Item ID: D206-667-101TRN

Item Name: Crosstube Turning Detail

DART AEROSPACE LTD	Work Order:	88978
Description: Crosstube Assembly (206B High Fwd)	Part Number:	D206-667-141
Inspection Dwg: D206-667-141 Rev: C		Page 1 of 2

DRAWING NO. D206-667-141	TITLE CROSSTUBE ASS'Y (206B HIGH FWD)	REV. C	DART AEROSPACE LTD ENGINEERING ORDER		D.E.O. NO. D206-667-141-C-1	SHEET NO. SHEET 1 OF 1	SCALE NTS
DRAWN 92	CHECKED ASS	MFG. APPR. [Signature]	APPROVED [Signature]		DE APPR. [Signature]		
DATE 11.07.15	DATE 11.07.20	DATE 11.07.21	DATE 11/6/21		DATE 11.07.21

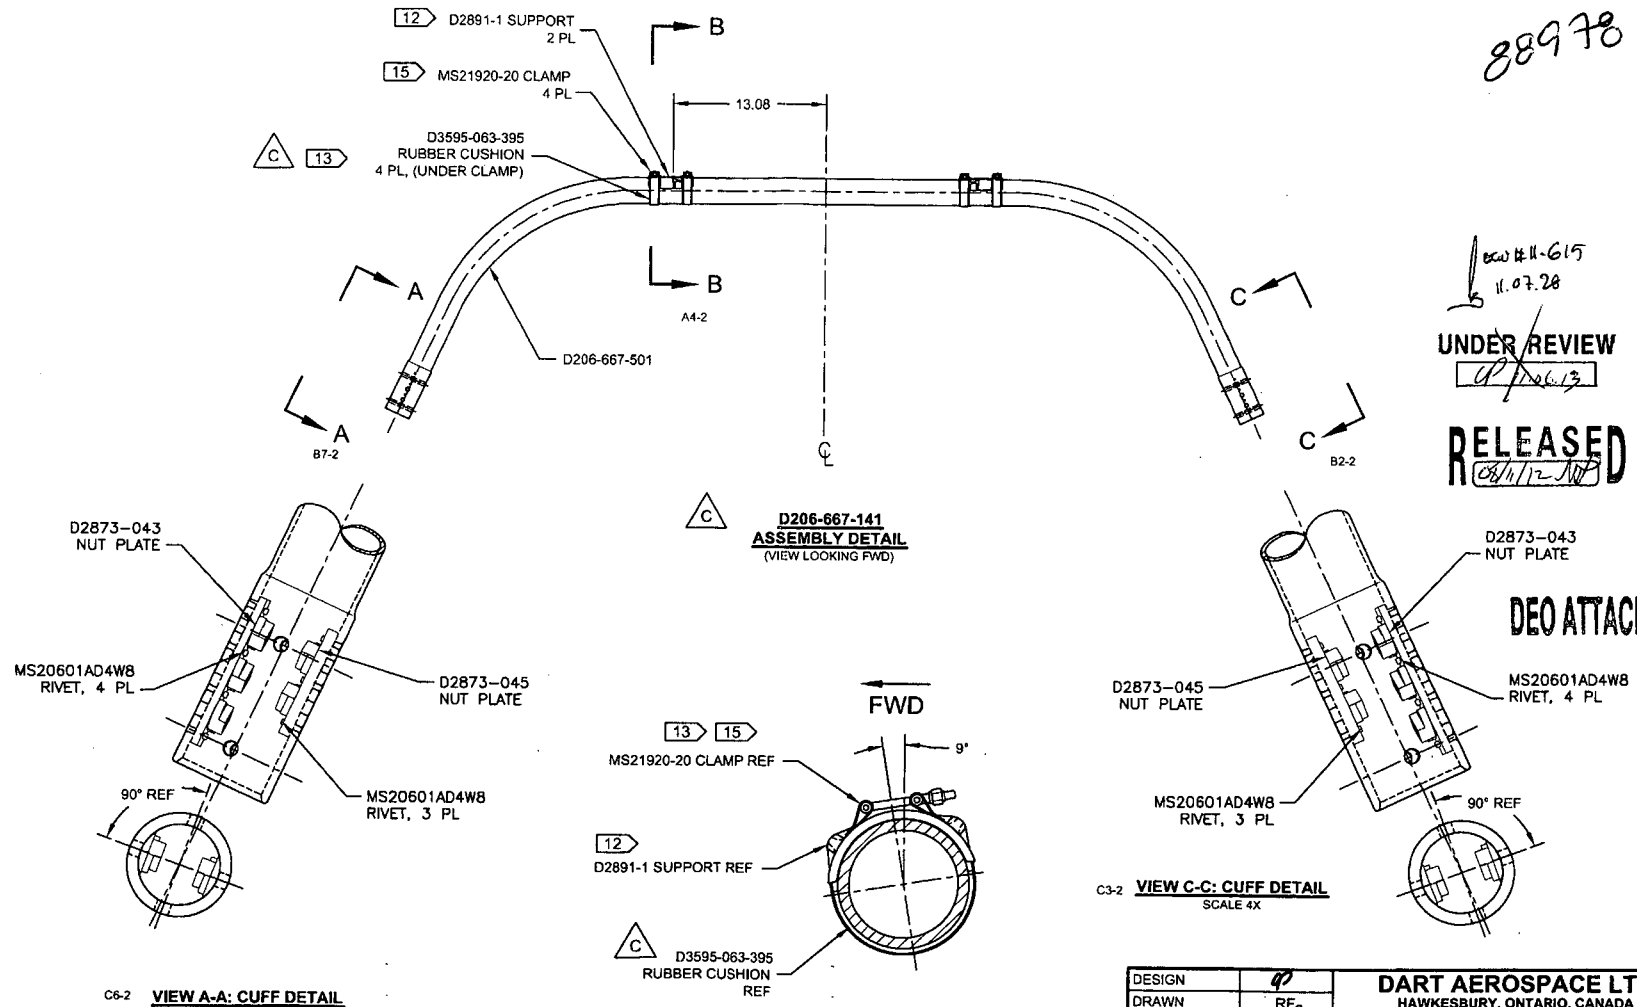
PURPOSE:

REPLACE MAGNOBOND WITH PROSEAL.

Item	Qty -141	Part Number	Description
9	A/R	PROSEAL 890 B-2	SEALANT, AMS-S-8802 CLASS B-2

NOTE 12 & 15, SHEET 1 IS AMENDED AS FOLLOWS:

- 12) TO INSTALL D2891-1 SUPPORT: ABRASE MATING SURFACE OF SUPPORT AND CROSSTUBE WITH 180-GRIT SANDPAPER AND REMOVE RESIDUE WITH MEK (OR EQUIVALENT). APPLY A 0.04" TO 0.07" THICK LAYER OF PROSEAL 890 CLASS B-2 (OR AMS-S-8802 CLASS B-2) SEALANT TO MATING SURFACE OF SUPPORT.
- 15) TORQUE CLAMPS 80 TO 100 IN-LB. ENSURE AT LEAST 1.5 THREADS SHOWING IN SAFETY AND THAT NUT HAS NOT BOTTOMED-OUT AFTER TORQUING. **PRIOR TO PACKAGING, RE-CHECK TORQUE ON CLAMPS AFTER PROSEAL 890 SEALANT HAS CURED FOR 72 HOURS.**
